Development Facilitation Team (DFT) – Review Comments

Project No: PR-2023-008674 Date: 05/08/2024 Agenda Item: #4 Zone Atlas Page: H-11

Request: Subdivision of Land – Preliminary Plat for Playa Del Sur

Location: 5720 Miami Rd NW between MIAMI and COORS BLVD NW

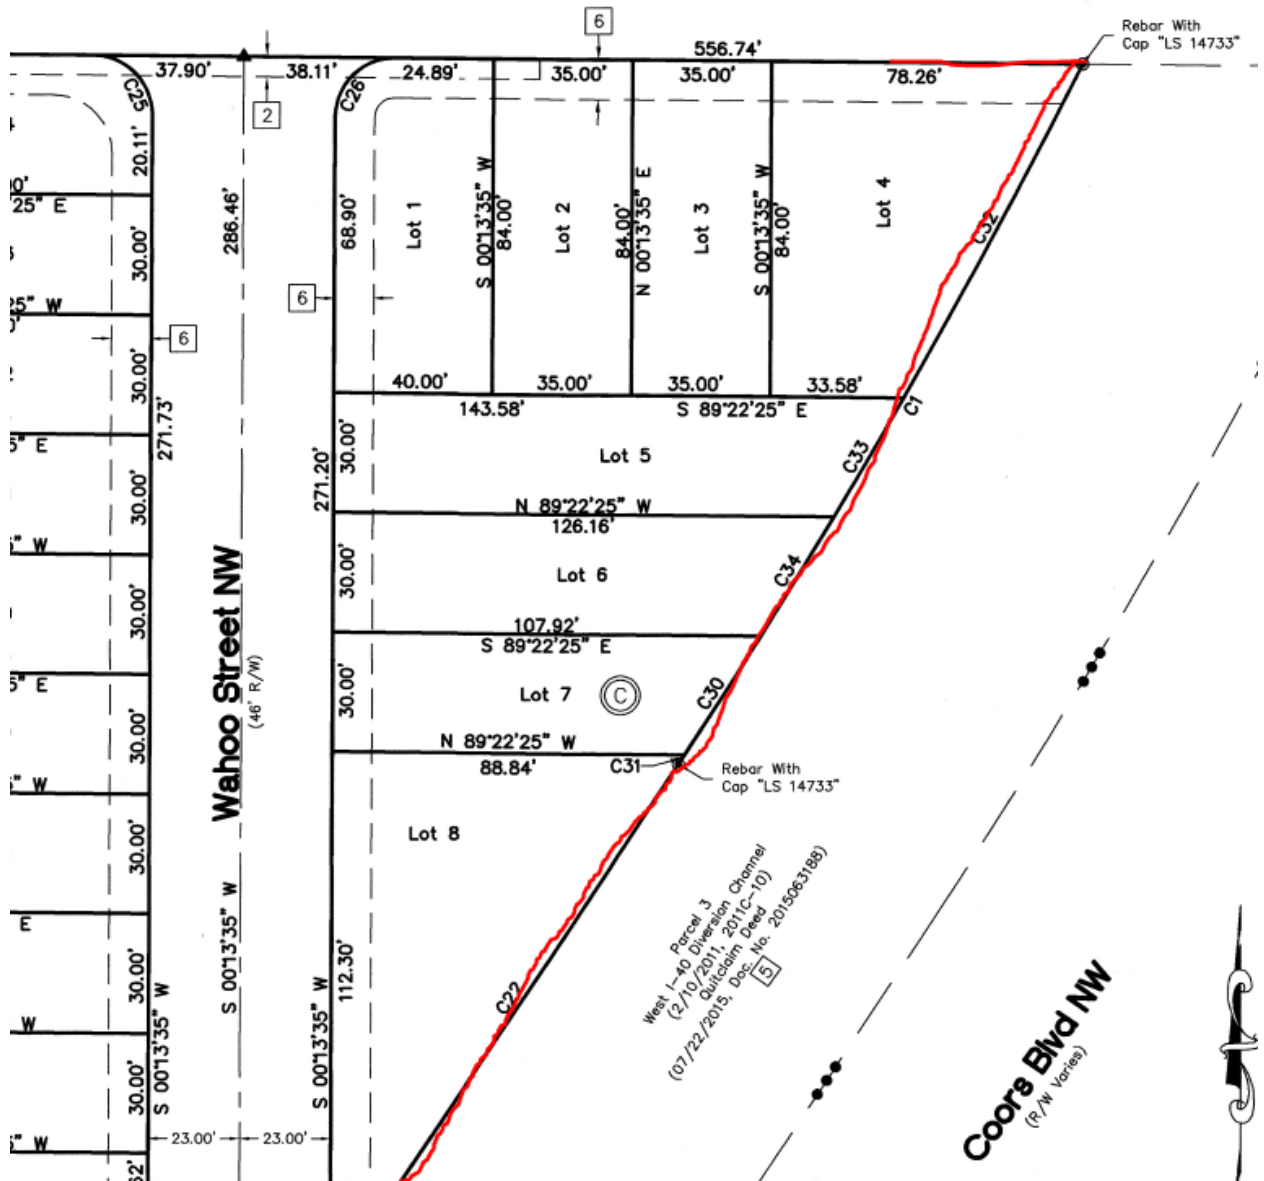
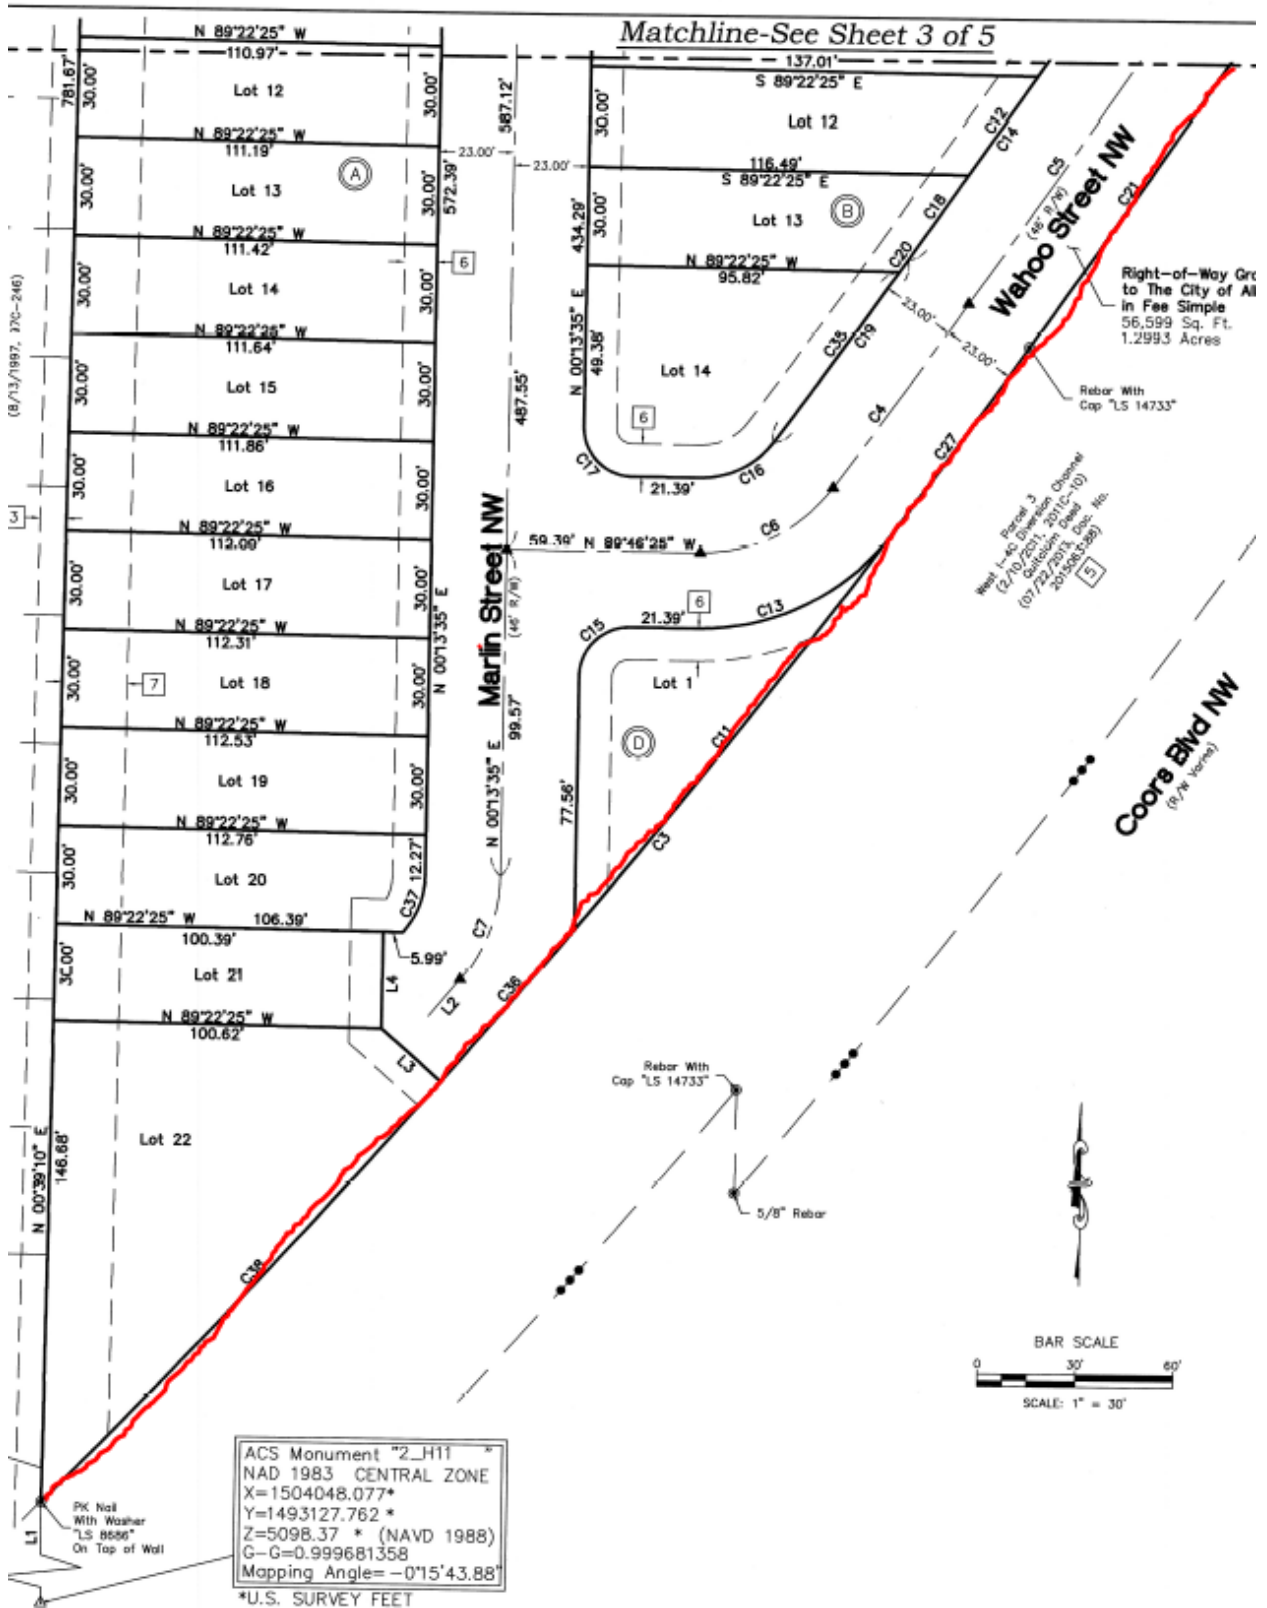
The applicant has discussed the following as mitigation measures: a perimeter wall all along the east property boundary. A continuous, opaque 8 foot CMU wall, not narrower than 6-inches, and with a variegated surface, possibly split-face faced block along the eastern property line and parallel to the I-40 onramps, is required to achieve public health in this area.

Staff has further requested that:

- (1) The **northeast corner of the site be redesigned** with a stub street so that no home faces Miami near Coors;
- (2) OR that the eastern perimeter **wall wrap around the northeast corner continuing 35-50 feet along Miami. The wrap around on the front yard would require a variance.** Without the wrap around wall, staff requests that additional noise readings be done during the entire peak period (not just 5:30 to 6:00 am) to see the exact mitigation measure, including wall design, that is needed for homes that would front on Miami. See figure below (8 foot CMU wall is shown in red):

- The perimeter wall design must be on a plat sheet that accompanies the plat and is approved with the plat to guide later stages of development when the perimeter walls are built. The following note must be added to the Plat: **“The developer of the subdivision is responsible for building noise walls and using building façade treatments to attenuate the traffic noise from the adjacent on ramps to I-40 West and Coors Boulevard.”**
- Confirm that all lots have a depth sufficient to allow a 20-foot driveway from garage to sidewalk beginning, with no sidewalk encroachment per IDO 5-3 below:

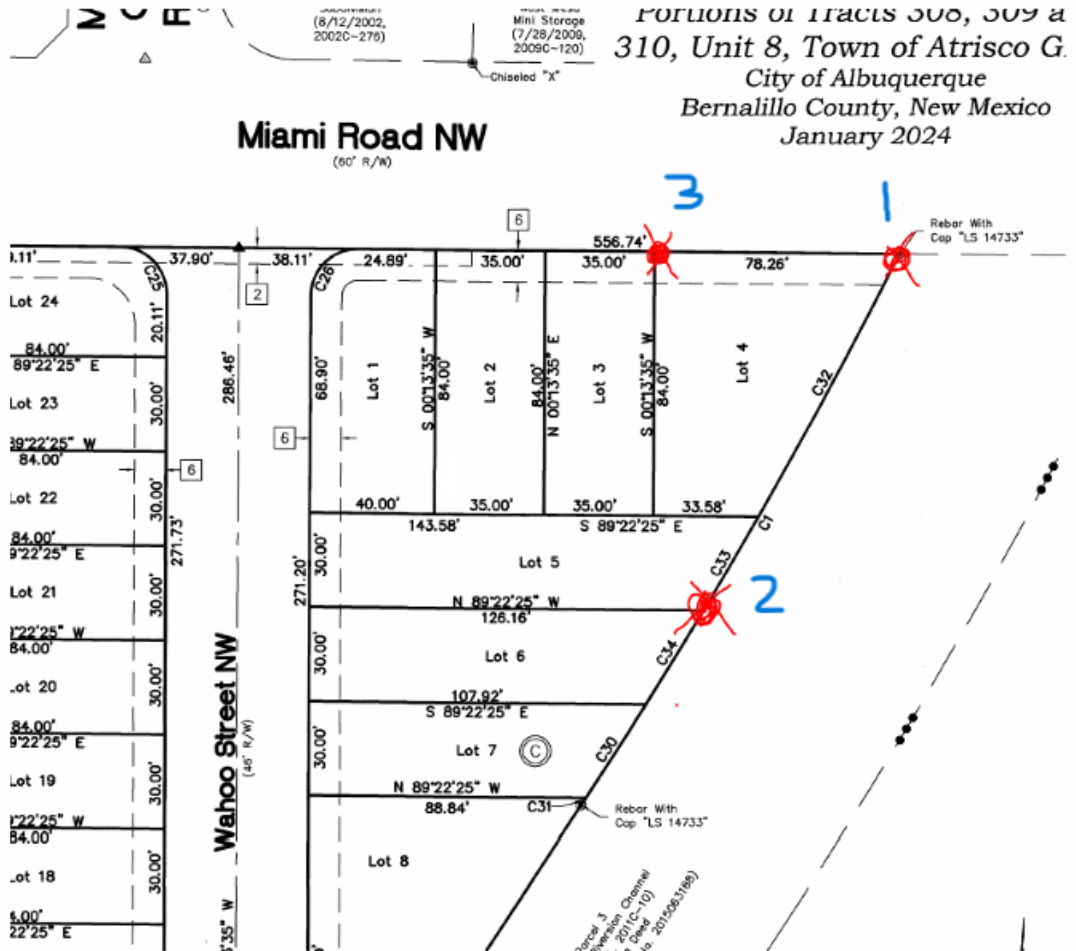
The location is not in a Center but within Major Transit Corridor area.

Miami Rd is considered a local street. 5' sidewalk and 4-6' landscape buffer is required.

The Sidewalk Exhibit included with the Preliminary Plat submittal as well as the IL depict 5-foot wide sidewalks along Miami Road, as well as along future proposed local streets within the subdivision which comply with Section 7, Table 7.2.29 of the DPM. The Sidewalk Exhibit also depicts landscape buffers that vary between 3.5-feet and 4.5-feet in width; **landscape buffers less than 4-feet in width would not be recommended for a new development. The landscape buffers of four feet provide a minimum width for tree survival; wider than 4 feet is recommended.**

- Planning staff have reviewed the Noise Study Report submitted as part of the Preliminary Plat application submittal, and additional noise readings/measurements may be needed in the locations noted in the exhibit below (1-3 in priority order).
